Type Coffee Vending Machine	Model <b>9100 – 95 – Opera Touch</b>	N° T.I. <b>02 - 2019</b>
Serial Number <b>See pag. 3/3</b>	Subject <b>CHANGE OF CAPILLARY THERMOSTAT 140 °C</b>	ISSUED FOR (X)
		Action Information <b>X</b>

**MODIFICATIONS:**

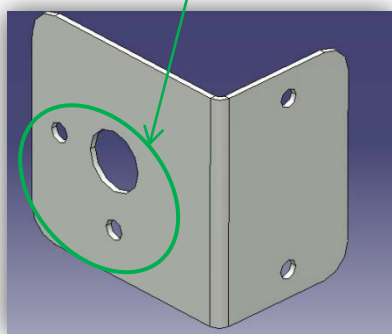
Be informed that the *safety thermostat* mounted on *Espresso* pressure boiler has been replaced by a **new** thermostat, technically interchangeable with the current one.

**Important note:** the two components **are not completely interchangeable**.

To mount the **new** thermostat on **pre – modification** machines, it's necessary to order the **new** thermostat *support* or the **new** pump and boiler *support*.

**New support for new thermostat**  
Spare code: **259710**

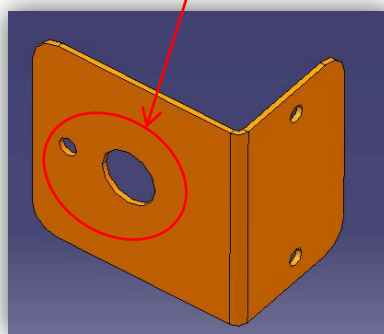
➤ **9100 - 95:** the two *thermostats* are **interchangeable only** by ordering the *new* thermostat *support*.  
The **pre-modification** thermostat can also be mounted on this support.

**New pump and boiler support**  
Spare code: **259088**

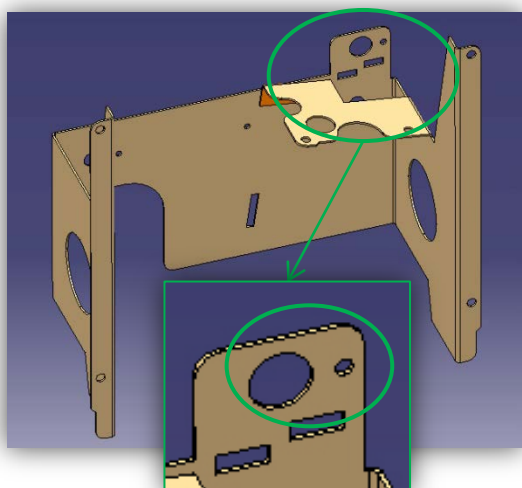
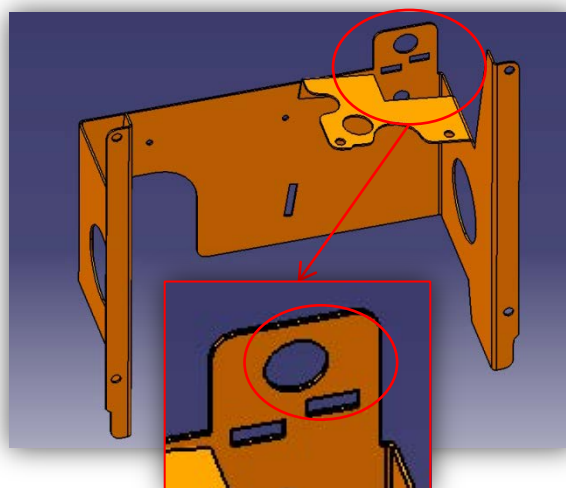
➤ **Opera Touch:** the two *thermostats* are **interchangeable only** by ordering the *new* "pump and boiler" *support*, whose spare code is: **259088** (the **pre-modification** thermostat can also be mounted on this support).

**New thermostat**

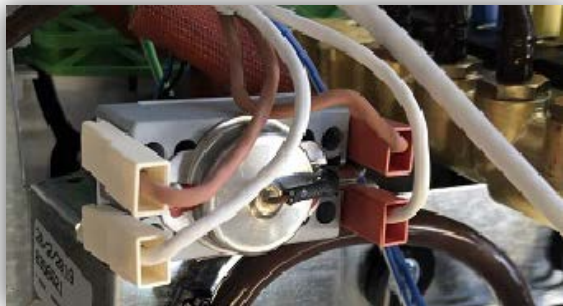
**Important note:** the **new thermostat** introduction did not require any modification of the wiring assembly, but the **positions** of the fast-on connectors have changed, as shown below.  
Connect the connectors respecting numeration "**11, 12, 21, 22**" – See pictures below
